## Development Permit Panel

Wednesday, March 29, 2017  
3:30 p.m.

1. **Development Permit 16-740024**  
(REDMS No. 5321653) (File Ref. No.: Xr: HA 16-744661)

**2. Development Permit 16-740665**

SHEET TITLE  
THIRD FLOOR PLAN,  
ROOF TOP FLOOR PLAN,  
EAST & WEST ELEVATION

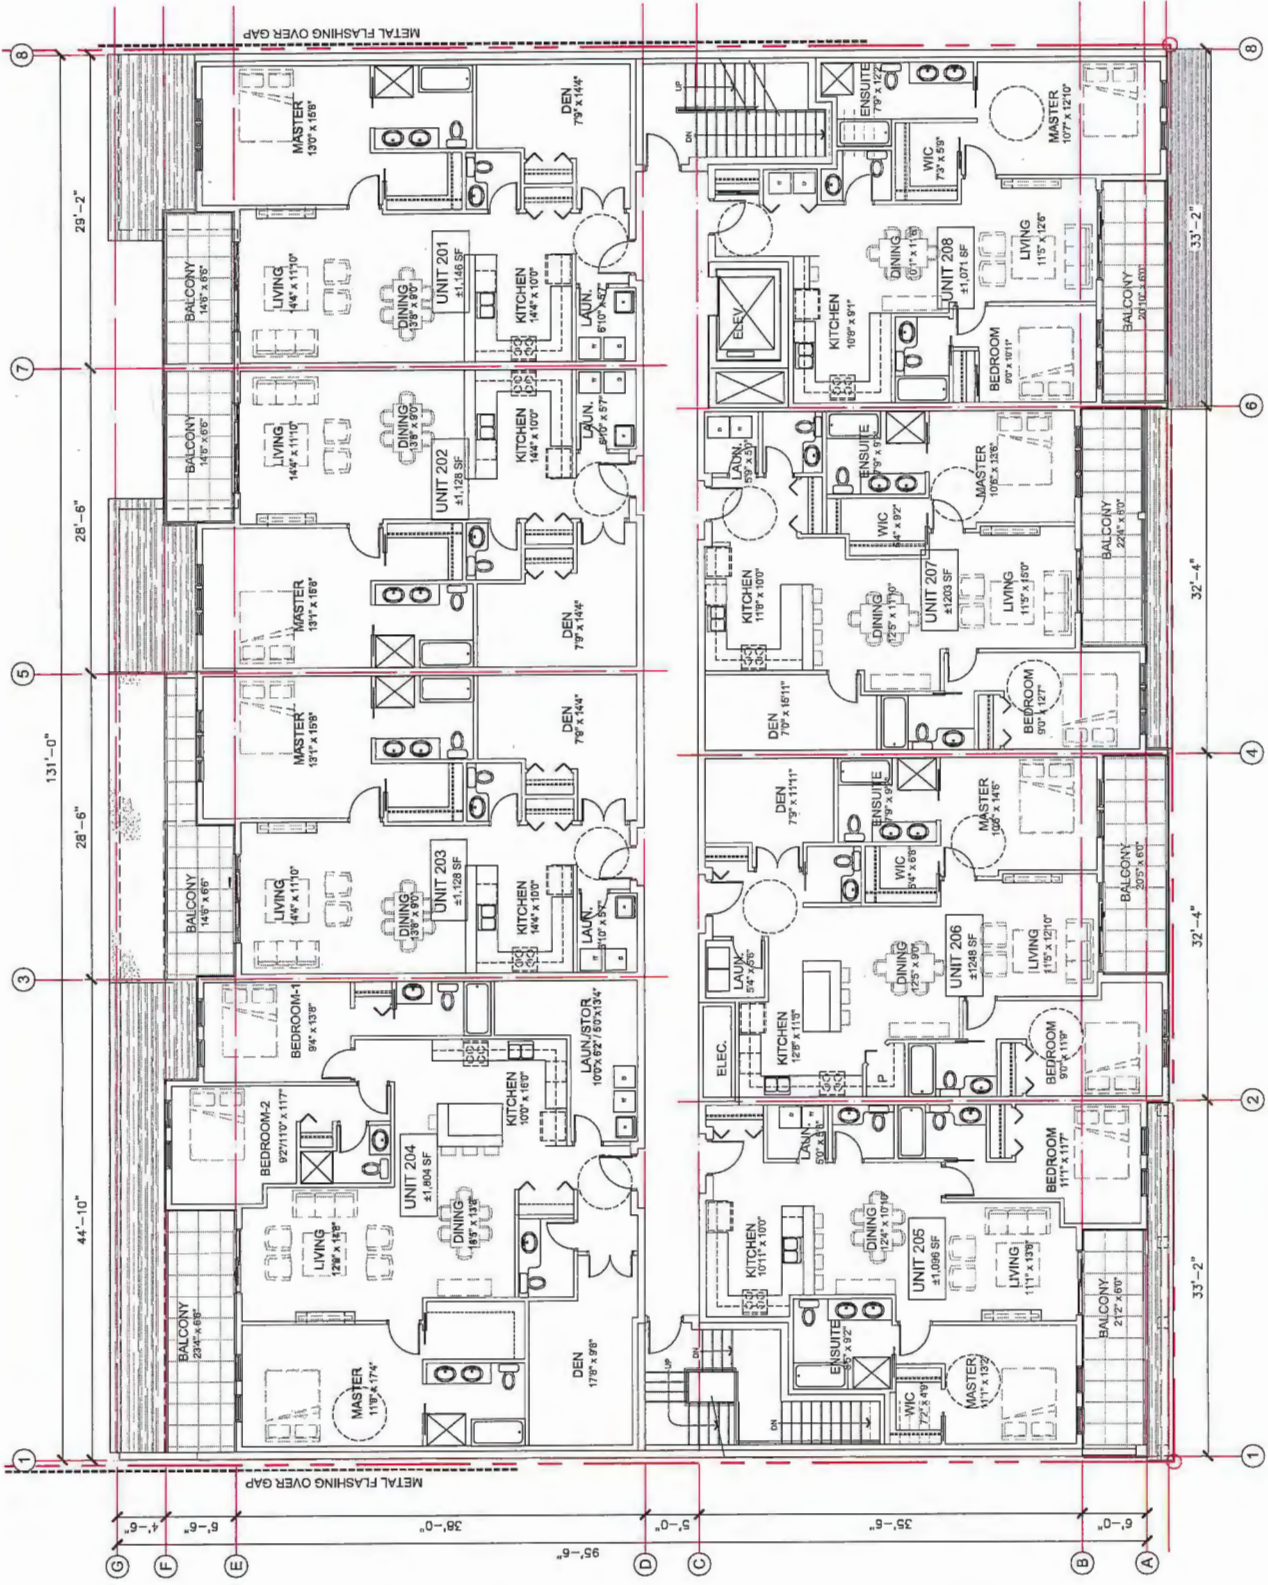
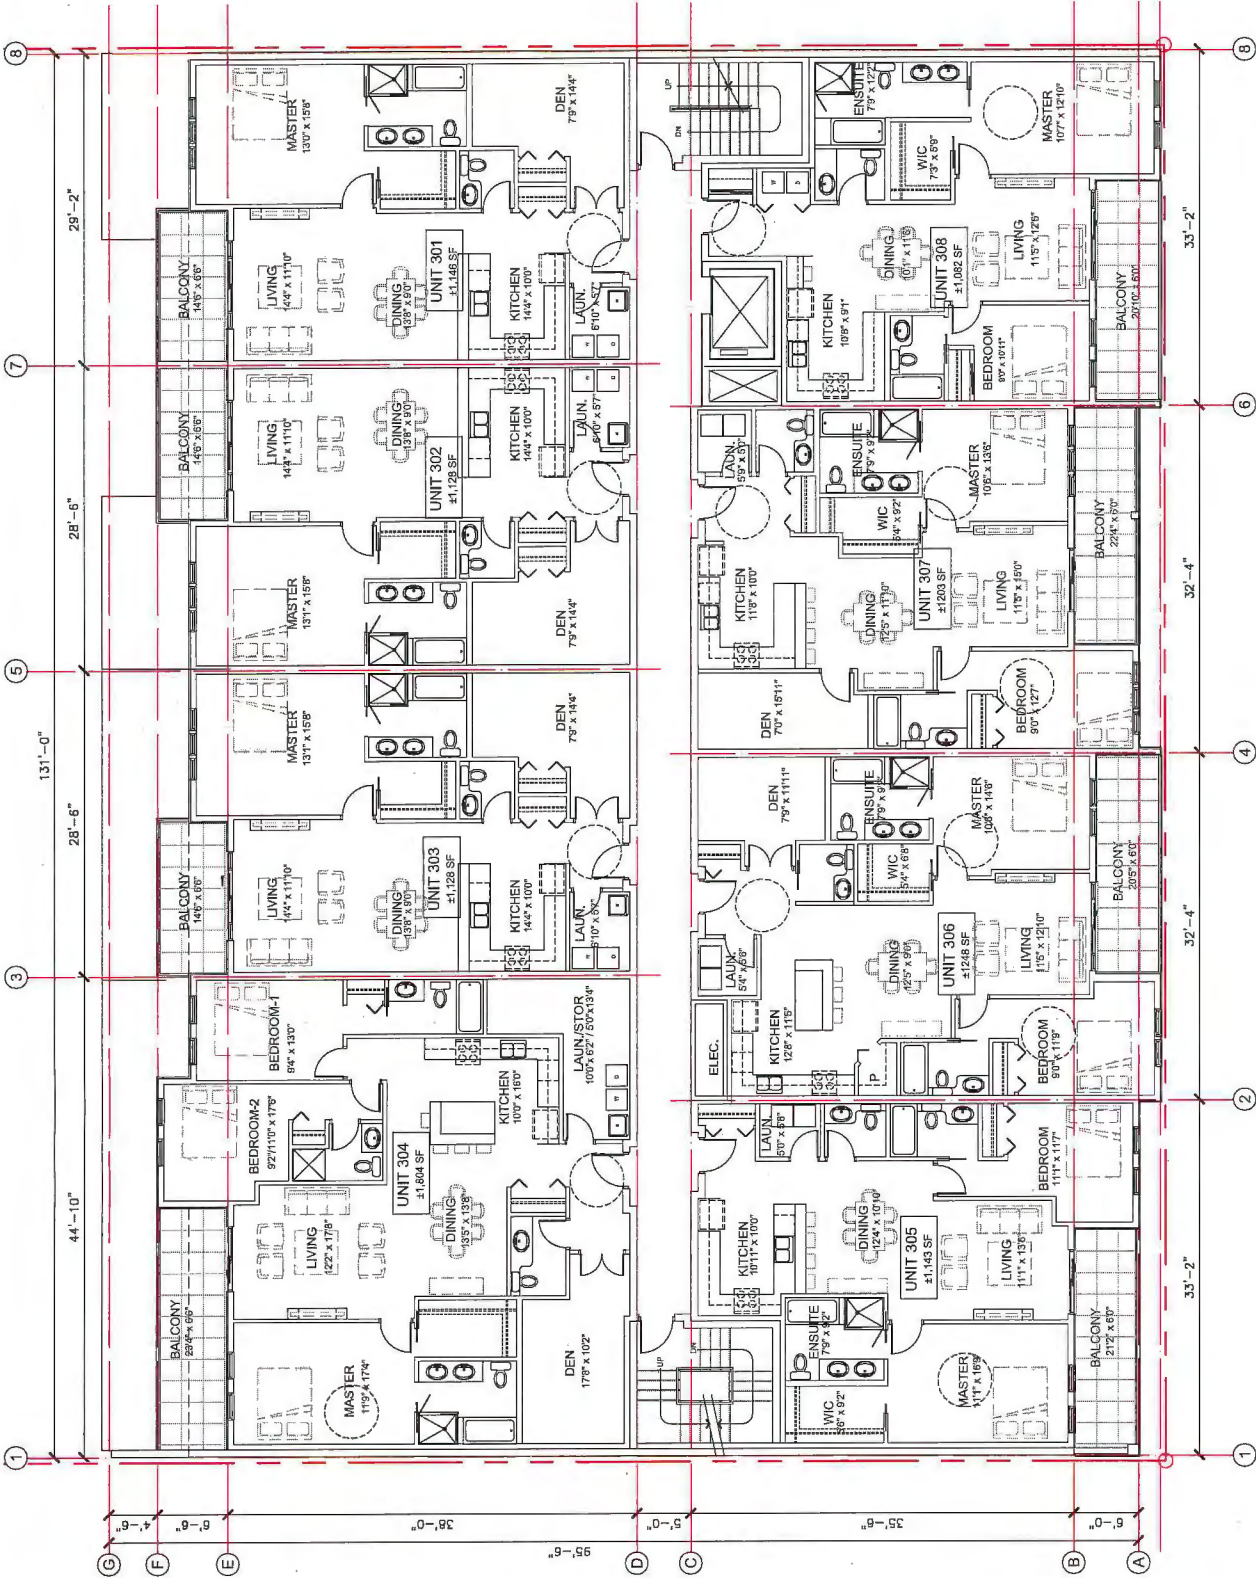
- the siting of the small storage area for garden tools on the rooftop is tricky; consider adjusting the position of the door to provide an easier and more efficient access; *East rooftop stair enclosure now replanned to flow better.*

- appreciate the proposed rooftop outdoor amenity area and support the proposed building height variance; *Elevator structure overrun retained, but trellises over raised planters have been deleted.*

- appreciate the use of glazing on one side of the projecting stair shaft on the rooftop; consider introducing glazing to the other side to allow natural sunlight to the corridors below; *Similar glazing added to west enclosure.*
